Contract Program: Technical Support for the Reactor Systems Branch (L1697/P2)

Subject of Document: Review of Proposed Modifications to Emergency Procedure
Guidelines for Anticipated Transients Without Scram Events

Type of Document: Technical Evaluation Report

Date of Document: November 1995

Figure 1. Suppression pool temperatures calculated by TRAC-BF1 following a MSIV isolation ATWS. Downcomer level is maintained at either MSCWL or TAF + 5'.

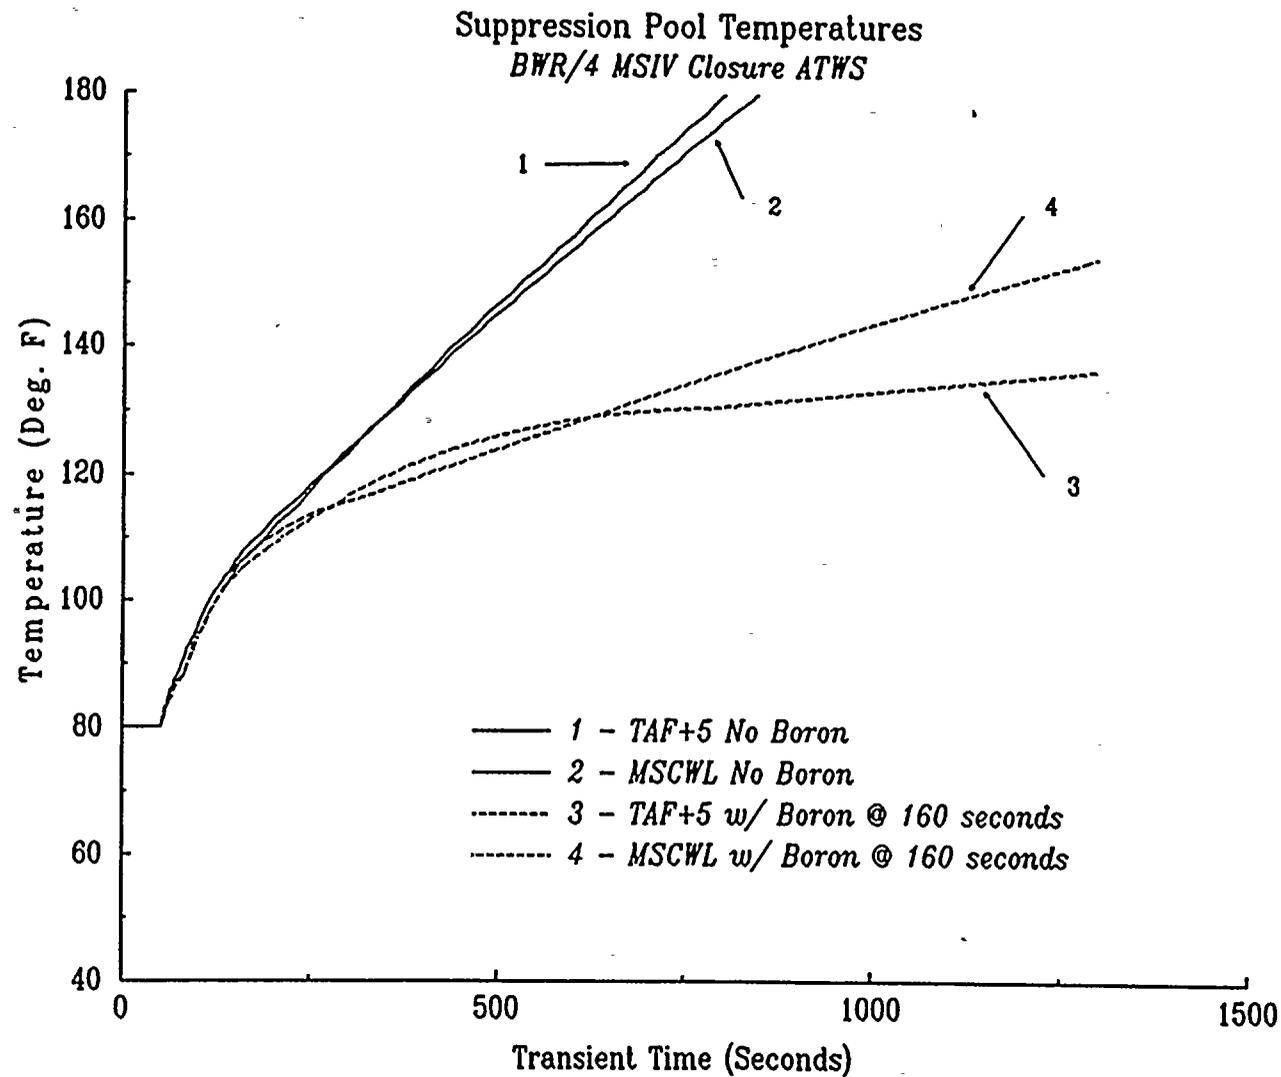
As it can be observed in Fig. 1, the staff calculations indicate that the higher-level strategy (TAF + 5') results in a lower suppression pool temperature than the low-level (MSCWL) strategy. This calculation also indicates that, as long as the hot shutdown boron weight (HSBW) is injected in approximately 20 minutes and the stratified boron is remixed promptly when the level is raised, the difference between the two level-control strategies is not significant in the sense that both strategies have sufficient margin to the heat capacity temperature limit (HCTL) and result in safe shutdown of the reactor. The results shown in Figure 1 also indicate that, if boron injection fails, both strategies reach the HCTL in 10 to 15 minutes and the difference in performance between the two strategies is not large.

The results of the staff calculations also indicate the need for immediate water level reduction once an isolation ATWS event is identified. As seen in Figure 1, the suppression pool is heating up very rapidly for the first few seconds when the level and power generation is high; thus, relatively small changes in assumptions for timing of operator actions in this phase of the transient result in very large discrepancies in the final suppression pool temperature. For example, the calculations reported in ref. 7 indicate that if the operator does not take immediate control of feedwater flow and other injection sources, the suppression pool reaches close to 150°F before the level is lowered and the pool heatup rate is reduced. Staff analyses based on the calculations of ref. 7 indicate that if the EPG procedures (which require prompt operator action) had been followed the final pool temperatures calculated by SABRE for the two level strategies would have been similar to the ones shown in Figure 1.

Figure 2. Comparison of power levels during a MSIV closure ATWS with water level control at MSCWL versus TAF + 5'. Power oscillations are caused by SRV actuation.

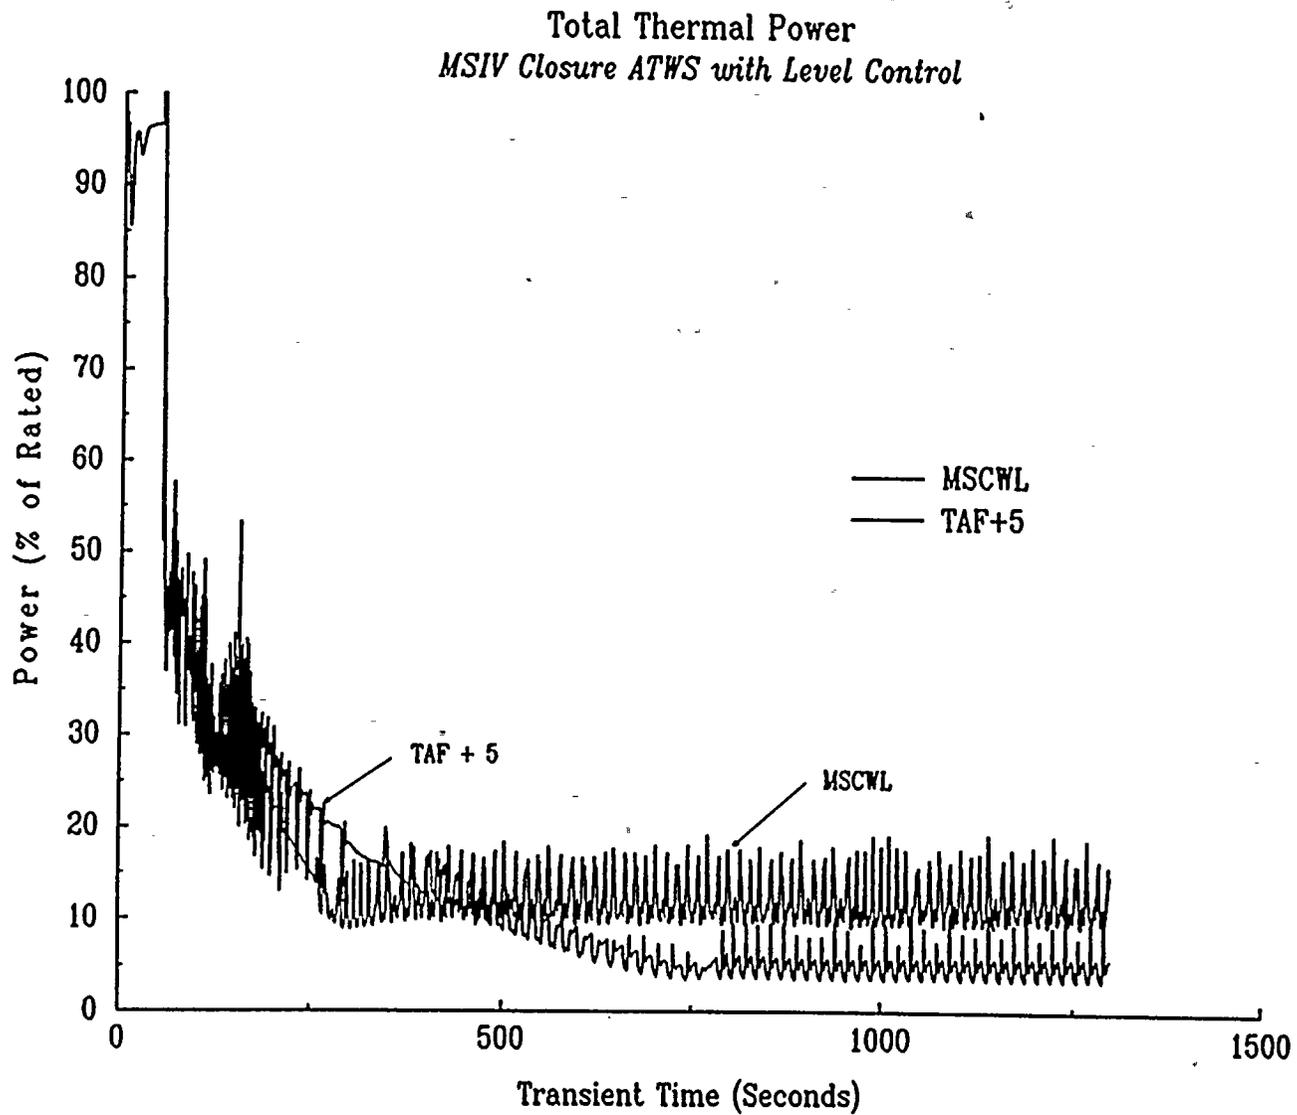
Figure 2 shows the core power calculated by TRAC-BF1 for the same MSIV isolation ATWS events represented in Figure 1, and Figure 3 shows the core boron concentration for the two strategies. These two figures show more clearly the advantage of the higher-level strategy. As a consequence of maintaining the high level, the power generation is higher for the first 500 seconds, but after that the power drops significantly below the MSCWL case, because boron continues to be mixed for 750 seconds until a concentration of 300 ppm is reached. This boron concentration is sufficient to reduce the power and drop the flow to 5% (the flow at which boron is assumed not to mix), as seen in Figure 4.

Figure 5. Comparison of core average void fraction for a MSIV closure ATWS event with two different level control strategies.

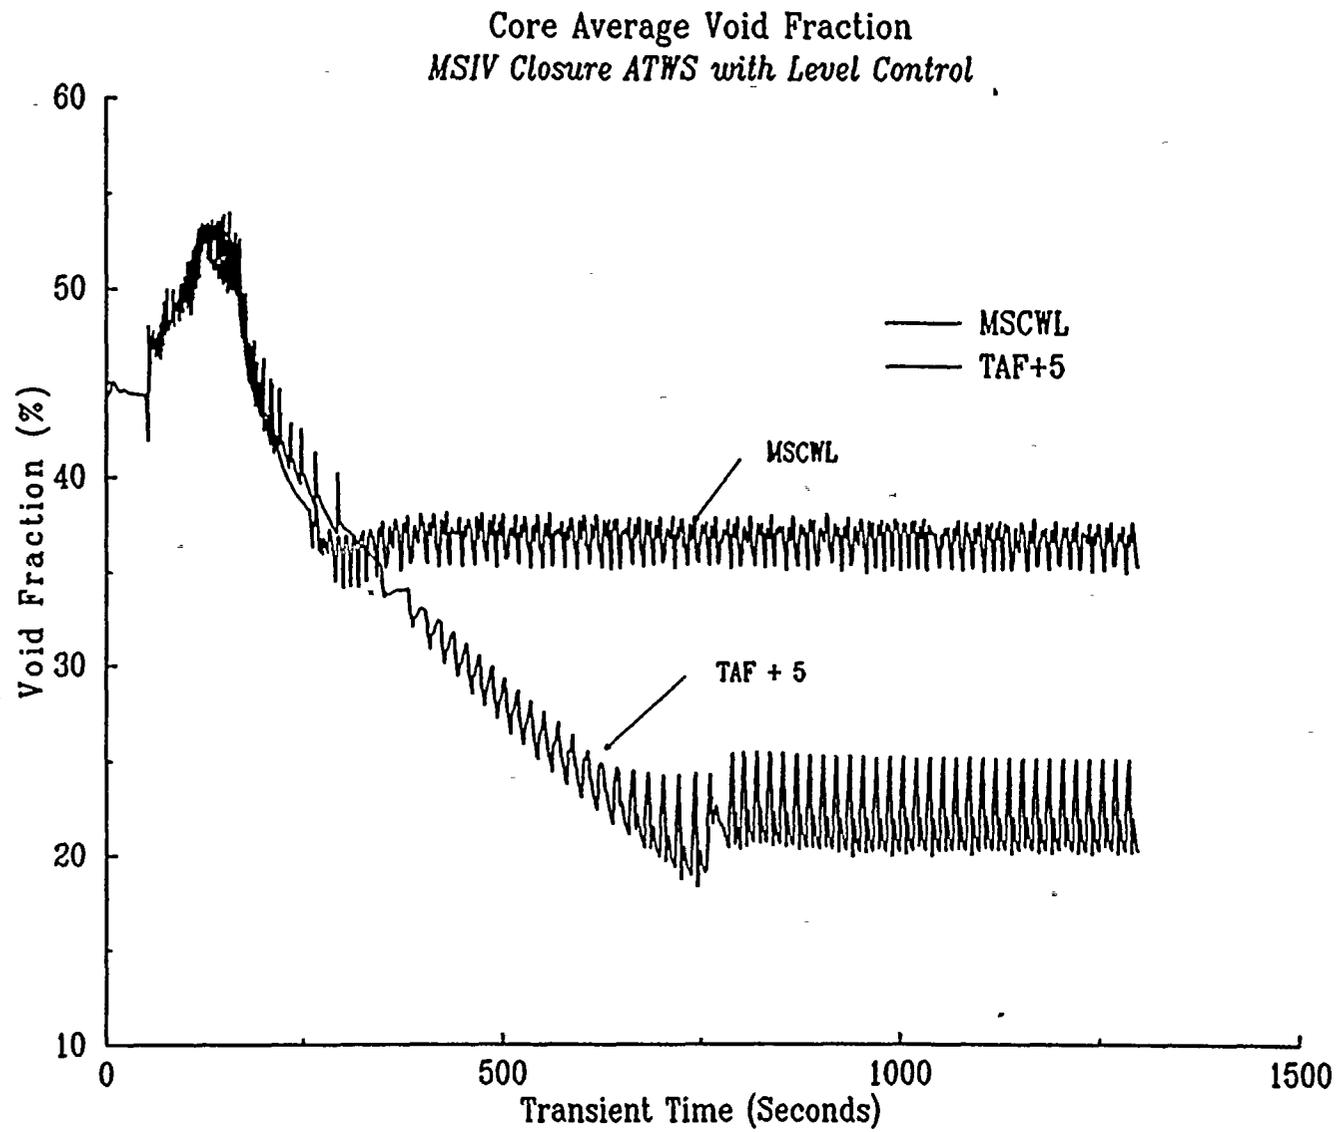
Figure 5 shows the core average void fraction for the two level-control strategies studied. This figure shows that as expected, to maintain the level at MSCWL, the reactor requires a higher void fraction than when the level is higher at TAF + 5'; thus, a higher power is required at the lower level to maintain the same flow (approximately 5%).

The NRC calculations have also shown that the two-phase level is well-above the core (indeed, in most cases, the two-phase level is at the separator level) even when the level is at the MSCWL. As seen in Figure 5, the core average void fraction is lower with the level at MSCWL than at nominal conditions (time zero in Figure 5). This fact indicates that the core is likely to be covered with a two-phase mixture. The core coolability is confirmed by studying the peak clad temperatures calculated by TRAC-BF1. Figure 9 represents a composite of ten different TRAC-BF1 calculations, and it shows the maximum clad temperature in the low-power channel (expected to have the limiting performance). This set of TRAC-BF1 calculations includes collapsed water levels from TAF + 5 to MSCWL, and it shows that the clad temperature is well within acceptable limits. Indeed, for most transients, the peak clad temperature is lower than at rated conditions (time zero).

Figure 6. TRAC-BF1 and RAMONA-4B calculated power as a function of downcomer water level with 25 °C feedwater. Sharp drop in power at TAF - 40" (TRAC-BF1 calculation) corresponds to flow stagnation.

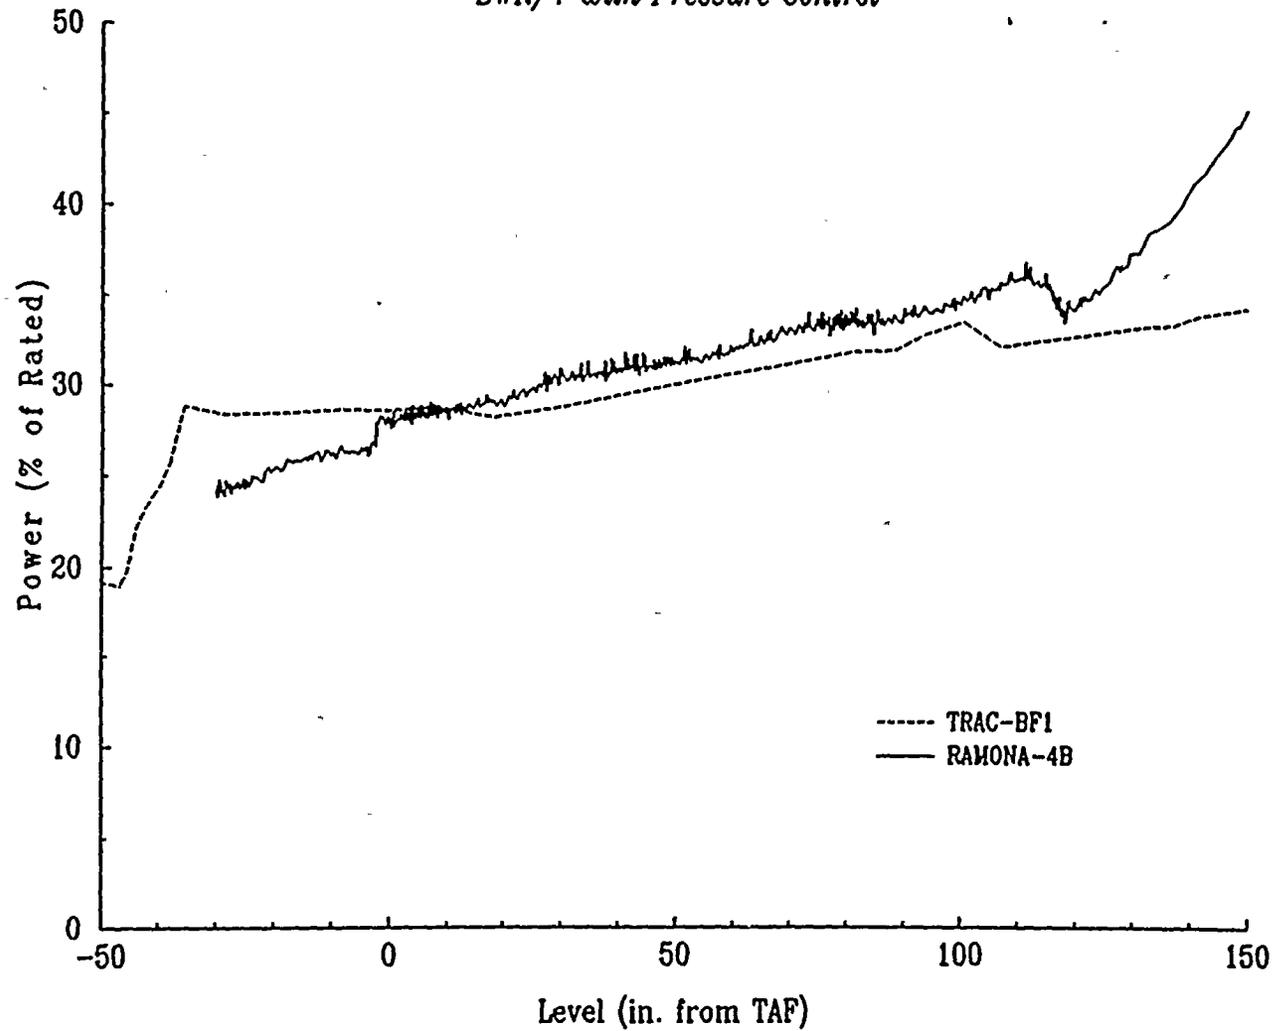
An unexpected result of the staff calculations is the small dependency observed between power and level once the level is lowered below TAF + 5'. Figure 6 shows the core thermal power as function of downcomer water level. This figure has been produced by plotting the power and level during a TRAC-BF1 and a RAMONA-4B calculation in which the feedwater flow is slowly ramped down to zero. We can observe that both codes, TRAC-BF1 and RAMONA-4B, predict that the dependency between power and water level is fairly flat around the TAF area. This is the reason why the differences between the two level strategies are not as large as expected when the SLC system fails.

The sharp step change in power seen in the TRAC-BF1 calculation shown in Figure 6 at around TAF - 40" corresponds to the stagnation of the external flow recirculation path. The RAMONA-4B calculation (which does not correspond to the same reactor or initial conditions that the TRAC-BF1 calculation) predicts slightly higher recirculation flows than TRAC-BF1 and does not predict flow stagnation even for a water level as low as the top of the jet pumps (TAF -50"). For levels below TAF - 40", the core inlet flow is greatly reduced and equals only the flow of steam leaving the core; this results in a significantly lower power. The value of the flow-stagnation power calculated by TRAC-BF1 is slightly less than 20%. This number was previously assumed to be of the order of 8% based on an extrapolation of a number of REDY analyses.¹⁰ The larger value of the flow-stagnation power is consistent with other BWROG calculations² and is attributed to the fact that REDY uses a multiplicative slip void model, which is incapable of predicting accurately the void fraction distribution under flow-stagnation conditions.

Figure 9. Composite of ten different TRAC-BF1 ATWS calculations showing the maximum clad temperature of the low-power channel.

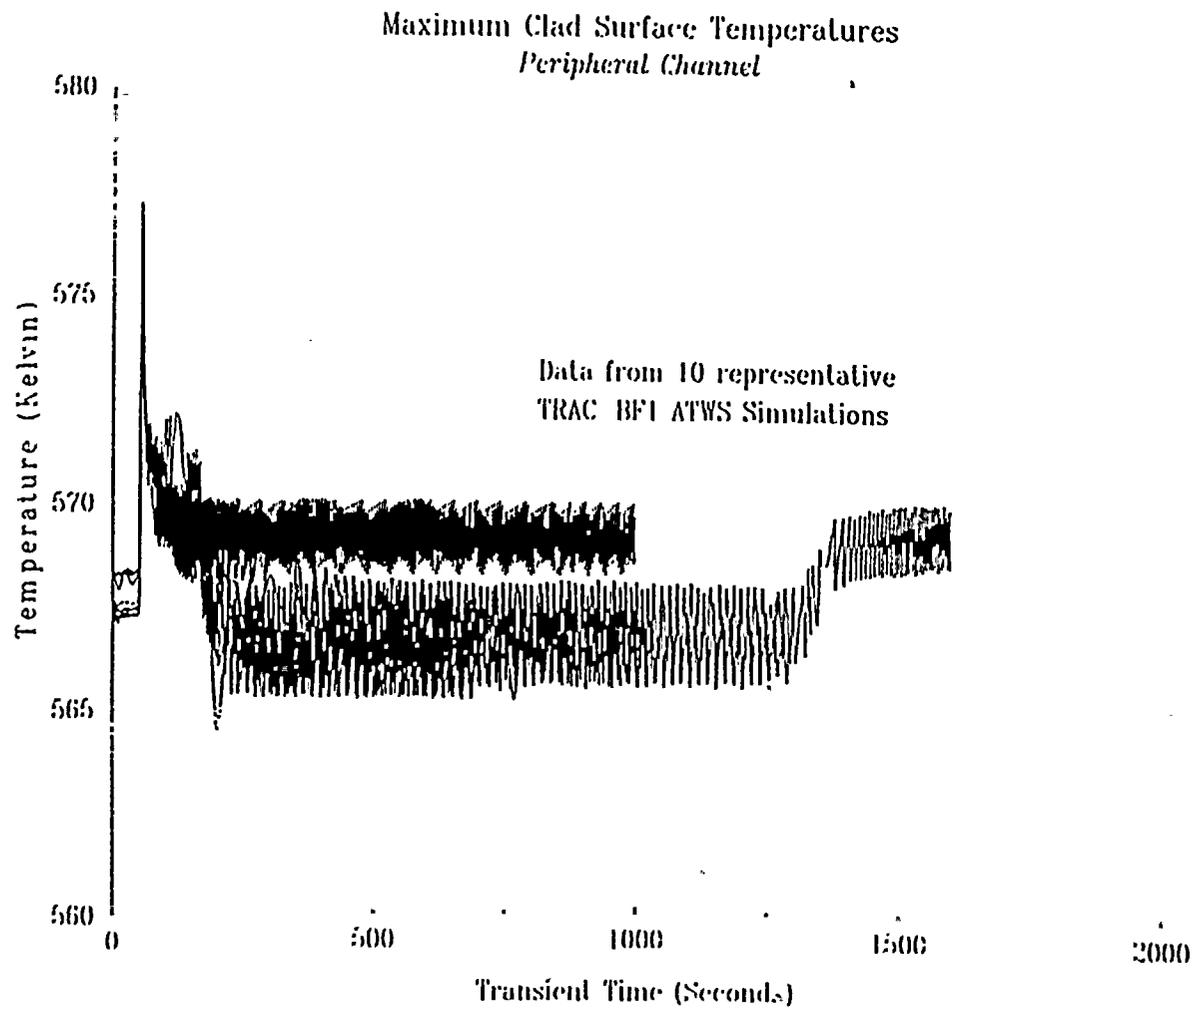
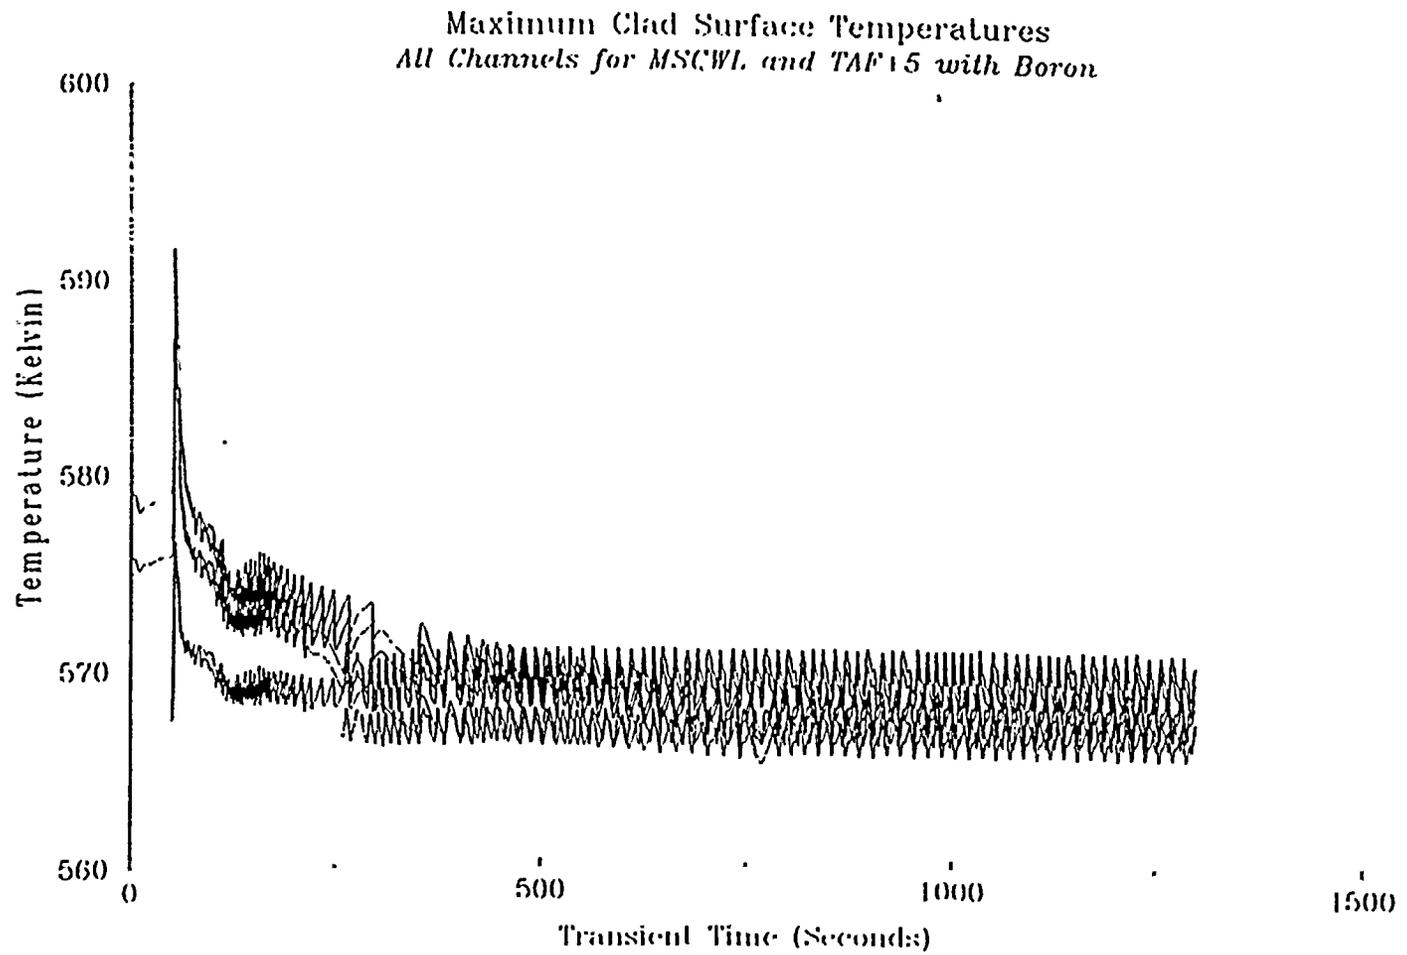
Figure 9 shows only the low-power peripheral channel for ten different TRAC-BF1 runs. Figure 10, in contrast, shows a composite of all the peak clad temperatures calculated by TRAC-BF1 for all channels in the two base runs: MSCWL and TAF + 5' level control with boron injection. This figure confirms that the peak clad temperature is within acceptable bounds, and it indicates that the two-phase level is well above the top of active fuel even when the collapsed water level is at the MSCWL.

Condensation-induced pressure fluctuations (concern (3) above) have been addressed in part by the TRAC-BF1 and RAMONA-4B calculations. Both of these codes have a mechanistic model for heat transfer between the subcooled liquid and steam phases; therefore, they compute the average equilibrium pressure that is reached in the node where steam condensation takes place. The result of these calculations exhibit pressure and power oscillations that are correlated with SRV cycling, but the magnitude of these oscillations is acceptable (see Figure 2), and it only results on peak clad temperature oscillations of the order of 5 °C, as seen in Figs 9 and 10.

Figure 12. Boron remixing time constant correlation from ref. 6

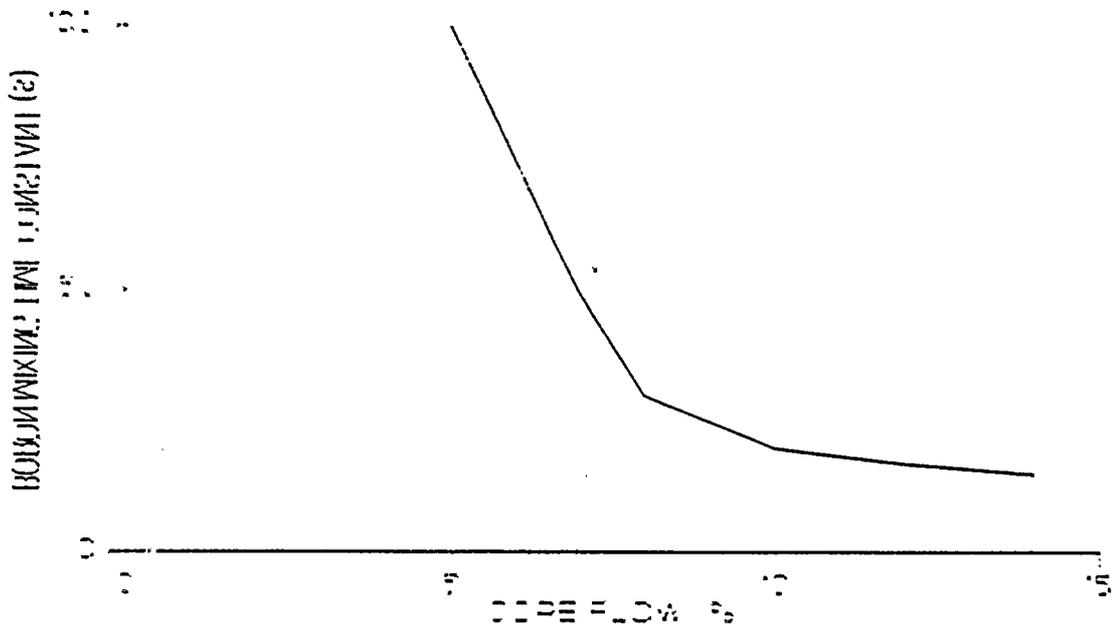
Successful ATWS management with all proposed strategies requires raising water level to remix the cold sodium pentaborate solution that precipitated to the bottom of the vessel when flow-stagnation conditions were reached. Figure 12 shows the remixing correlation determined from the 1/6 scale boron remixing experiments.¹⁰ The remixing efficiency is defined in terms of a "mixing time constant" (the time it takes to remix 50% of the stratified boron solution). From these experiments it was concluded that boron remixing would be essentially instantaneous (approximately 10 s) if more than ~10% recirculation flow is established once the level is raised.
